**Addendum No. 2
December 4, 2018**

Project: Rock Valley Event Center and City Hall Remodel
Rock Valley, Iowa
Project number 1130.2762.17

Architect: Architecture Incorporated

ADDENDA #2 - WEST TILE LINE

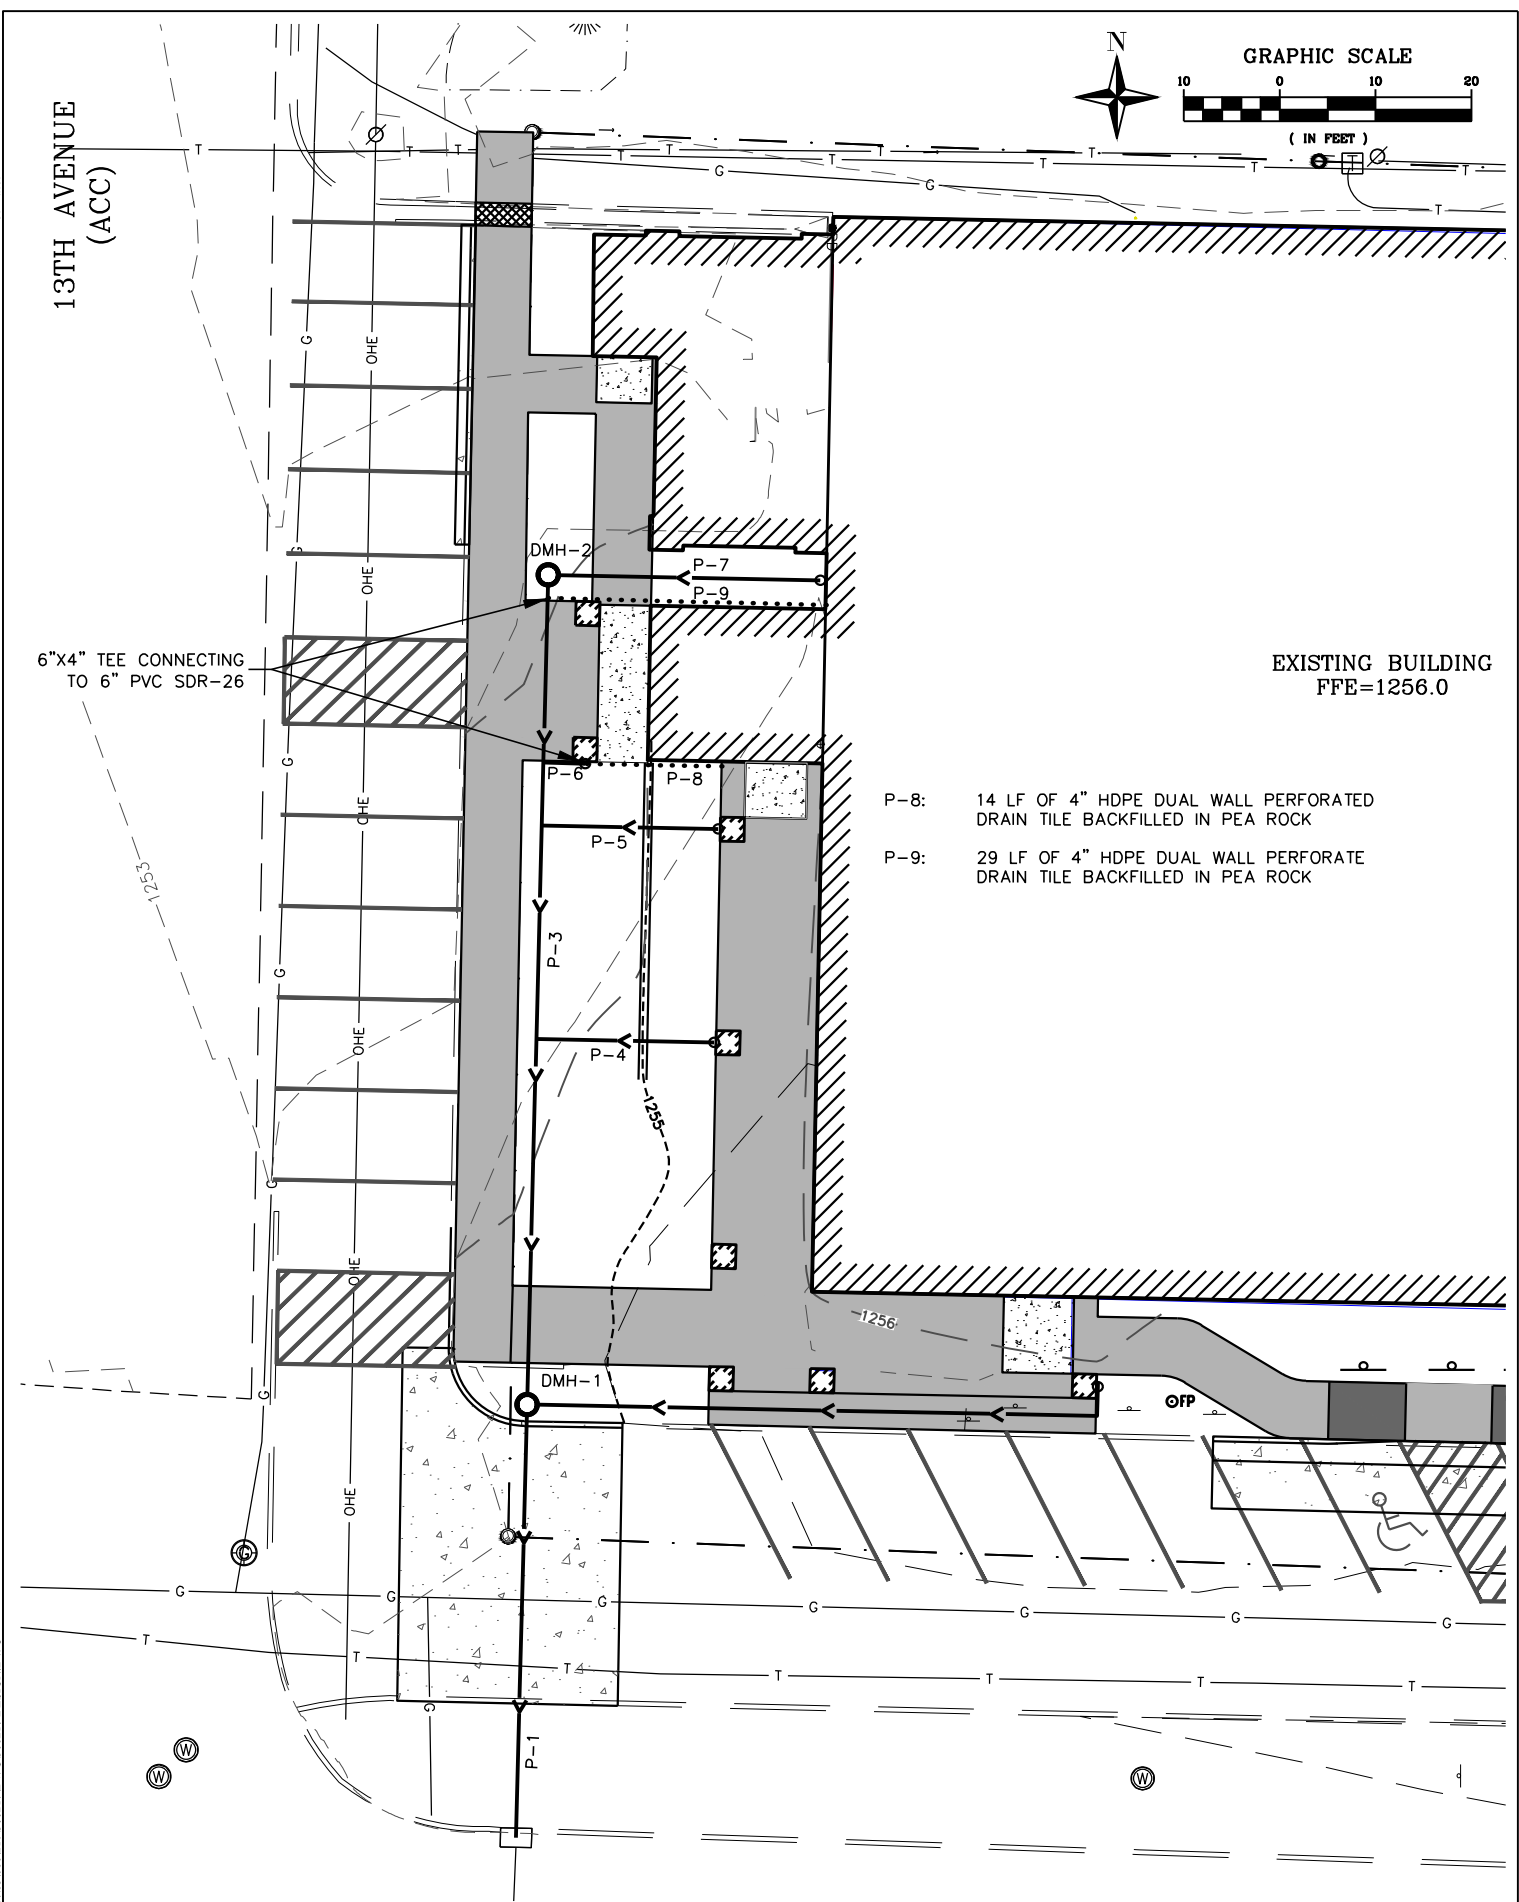
- 5) DRAWING 2.30 – SITE LAYOUT
 - a) Reference attached drawing Sheet 1 – Addenda #2 – West Tile Line dated 12-4-18 for drain tile on the north and south side of Vestibule 101. Connect drain tile to the storm pipe as shown.

- P-8: 14 LF OF 4" HDPE DUAL WALL PERFORATED DRAIN TILE BACKFILLED IN PEA ROCK
- P-9: 29 LF OF 4" HDPE DUAL WALL PERFORATE DRAIN TILE BACKFILLED IN PEA ROCK
